TRUCK, ELECTRONIC REPAIR AND TRUCK, COMSEC REPAIR, LIGHT, MC2 – LAND ROVER 110 6X6

REPLACEMENT OF MAIN SWITCHBOARD (CIRCUIT BREAKER PANEL) EARTH TERMINAL SCREW

MODIFICATION INSTRUCTION

Figure 1 – Earth Terminal Screw

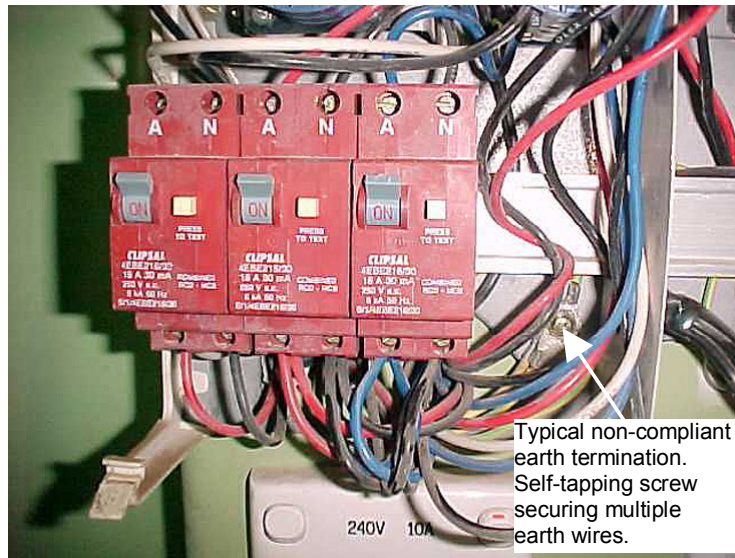
2. Various types of main earth terminal screws are fitted to these vehicles and, generally, they are self-tapping type of screws screwed into the rear metal cover plate of the switchboard (see Figure 1). This self-tapping screw is also used as the common earth terminal for a number earth wires entering the switchboard.

3. This self-tapping screw method of earthing multiple earth wires is not compliant with the requirements of AS/NZS 3000 and does not provide a reliable common earth point.

- a. Disconnect batteries and external power supply cables.
- b. Remove the circuit breaker panel cover (refer to EMEI Vehicle G 253).
- c. COMSEC variant only:
 - (1) The switchboard in the COMSEC variant is fitted with Metal Oxide Varistor (MOV) surge protection devices, which are wired to a separate self-tapping earth screw. Remove the MOV earth wire self-tapping earth screw from the switchboard rear metal panel and remove crimp lug from the earth wire.
- d. Remove self-tapping main earth screw from switchboard rear metal panel and remove and discard crimp lugs from the earth wires.

- e. Make an earth lead using 100 mm length of 2.5 sq mm green yellow/wire (Table 3, Item 1) and crimp lug (Table 3, Item 2). Using the self-tapping earth screw, connect this earth lead to the switchboard rear metal panel.
- f. Strip insulation from all earth wires, twist them together and terminate them into the tunnel lug (Table 3, Item 3).
- g. Using wire ties (Table 3, Item 4), tie and secure the earth wires into the switchboard wiring loom.
- h. Replace the circuit breaker panel cover (refer to EMEI Vehicle G 253).
